SUBJECT: Service Update for Inventory and Customer Vehicles
220 Amp Generator Fuse Block Corrosion
Expires with Base Warranty

MODELS: 2015 Chevrolet Silverado 2500 HD
2015 GMC Sierra 2500 HD
Equipped with 220 Amp Generator RPO KW5

Subject: 14154 – Service Update Bulletin
220 amp Generator Fuse Block Corrosion

4001472

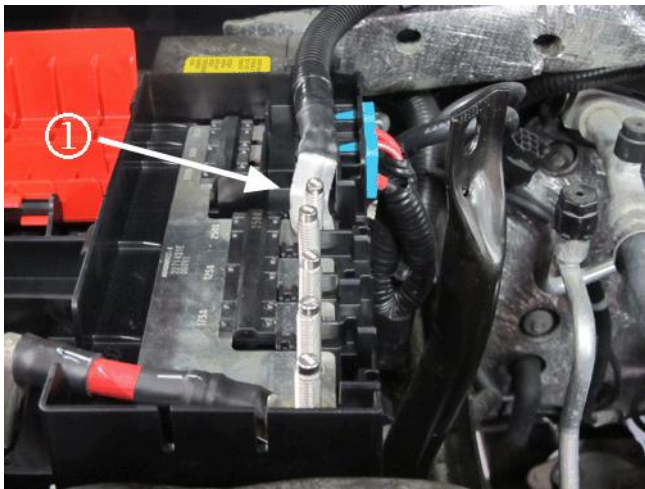
4. Remove the battery positive cable. Refer to *Battery Positive Cable Replacement (Single Battery)* or *Auxiliary Battery Positive Cable Replacement - Battery to Battery Relay K4B* in SI.

Tip: Shown in the graphic above, for easier access to the positive battery cable fastener at the junction box, disconnect the X121 connector (1).

5. Mount the new fuse battery distribution unit engine compartment block by snapping the block onto the battery lip.

Note: If disconnected during previous step, reconnect the X121 connector (1) after installation of the new cable.

4001473

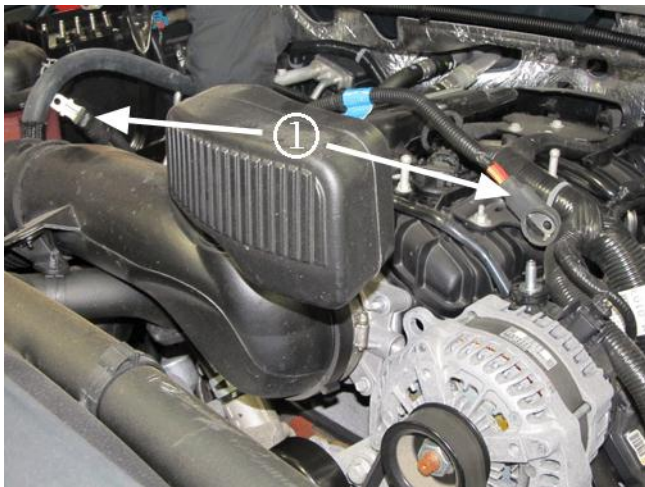
7. Position the battery positive cable eyelet (1) to the fuse block rear post, at #1 stamping.
